This letter is in response to your Lifeway project review letter of 02/12/2026, please see the revised drawings attached. Lifeway would like the existing Delafield driveway aprons to remain in service, as they are in reasonable condition. The area of the walk will be saw cut removed and replaced with concrete. Additionally, a small pothole will be repaired as well as any other damage caused during construction.

Project: 25-10151 Lifeway Foods Waukesha

Date: 2/19/2026

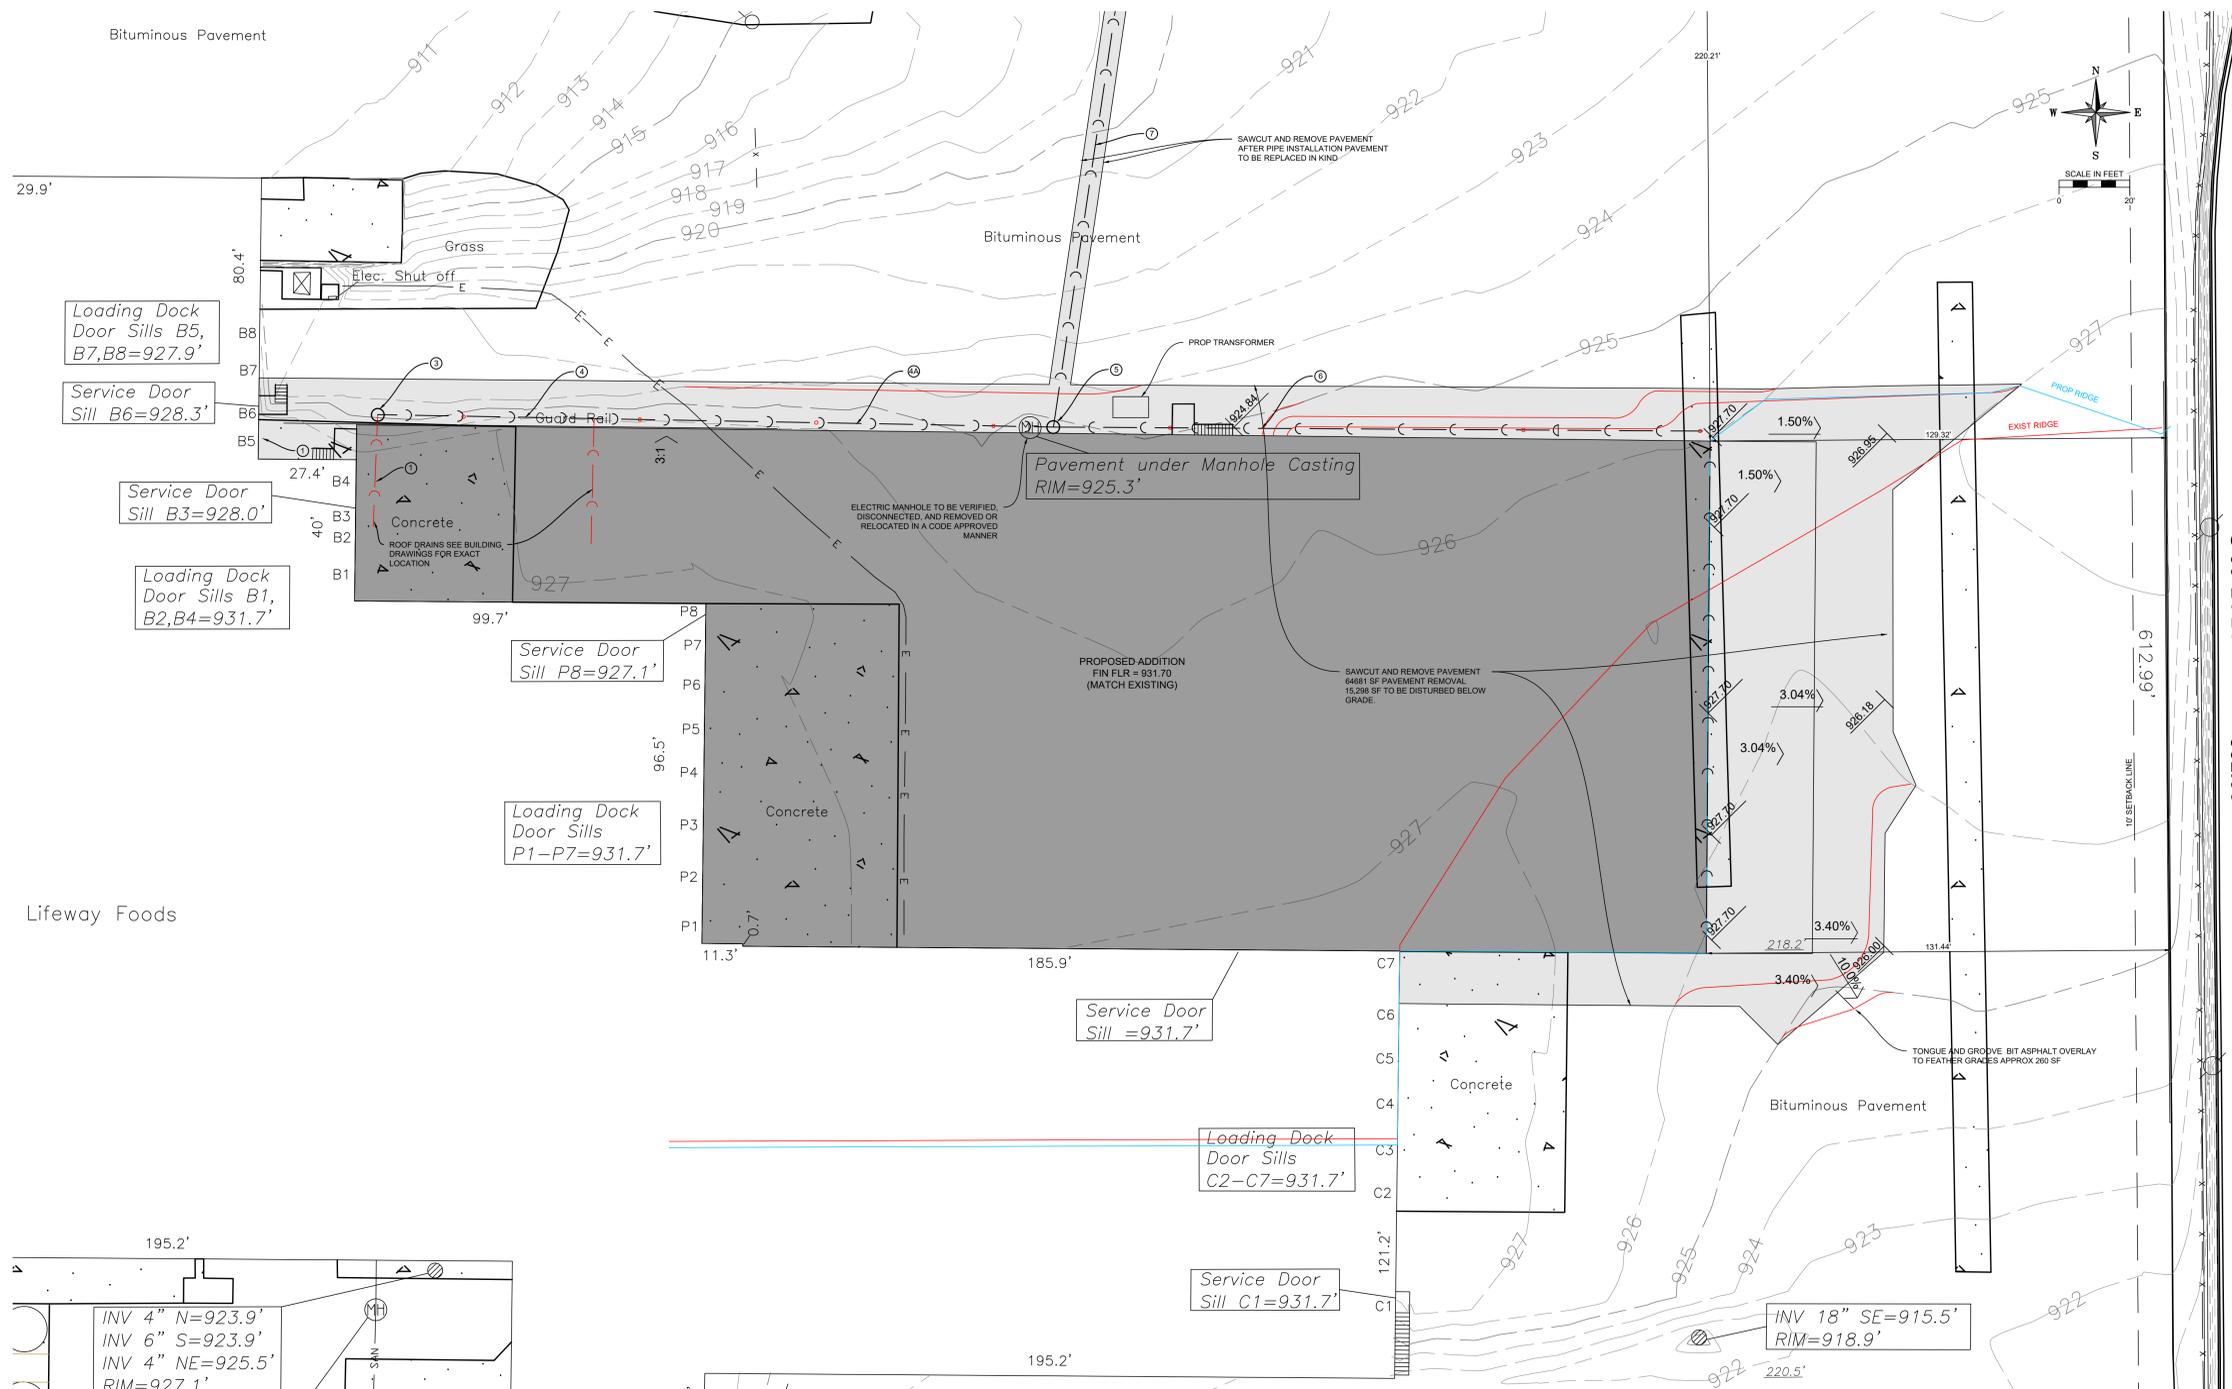
- 17 The building roof drains an additional 5188 SF of additional area to the North while the parking drive area directly East of the building drains an additional 2658 SF of area runoff to the South making it a near even swap as the additional 2,530 SF seems insignificant considering the size of both drainage areas. Exiting and proposed ridgelines are shown on the drawings.

THIS SITE DRAINS BOTH NORTH AND SOUTH BOTH DIRECTIONS ULTIMATELY DRAIN TO THE FOX RIVER.

NOTE PRE AND POST CONSTRUCTION RUNOFF COEFFICIENTS = .68 (100% IMPERMEABLE AREA)
